HP CP3520, HP CP 3525 and HP CM 3530™

Investigation by Delacamp has shown that there are two different versions of the CE25x cartridges. There are small differences in the toner hopper and one end cap which mean that the two types are not interchangeable. (see photo 1, 2 and 3) Mixing of these components leads to problems in assembly. If not noticed the misalignment will lead to very high load on the printer drive motor, causing the printer to stop.

1. Picture

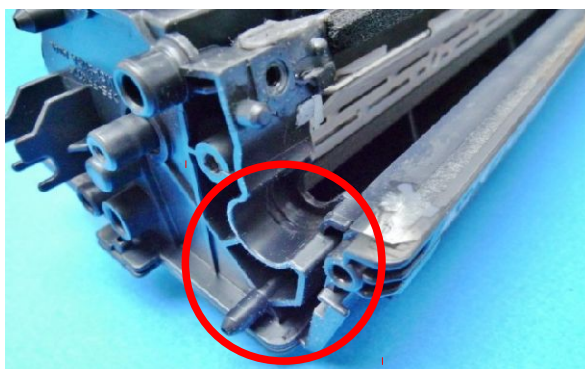
This picture shows the old style OEM hopper.

This picture shows the new style OEM hopper.

3. Picture

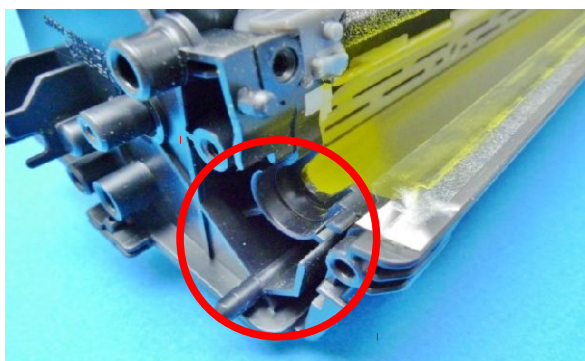
This picture shows the different versions of contact side inner end cap. (left old style, right new style)
